**CITY OF MADISON
INTERDEPARTMENTAL
CORRESPONDENCE**

To: Plan Commission
From: Matt Tucker, Zoning Administrator
Subject: 5110 High Crossing Blvd.

Proposed Use: Planned multi-use site including four-story, 106 room hotel and two-story health club.

Nietzel CSM : Section 27 - Town of Burke
 5110 High Crossing Boulevard
 Create 2 lots to allow construction of a 60,650 square-foot health club
 and 106-room hotel as a planned multi-use site
 Tim Nietzel - Young Crossing, LLC/Jerry Bourquin - Dimension IV-Madison

REQUESTED EASEMENTS - ALLIANT ENERGY

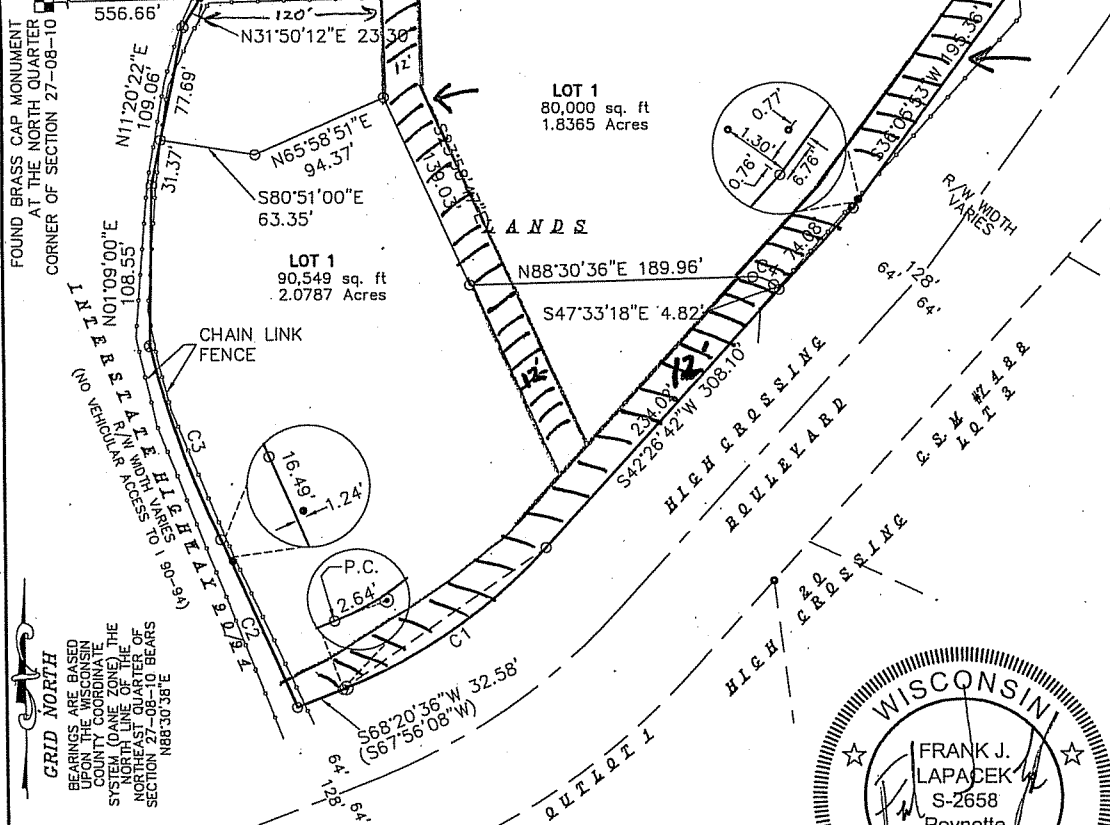
Please see attached for requested easements.
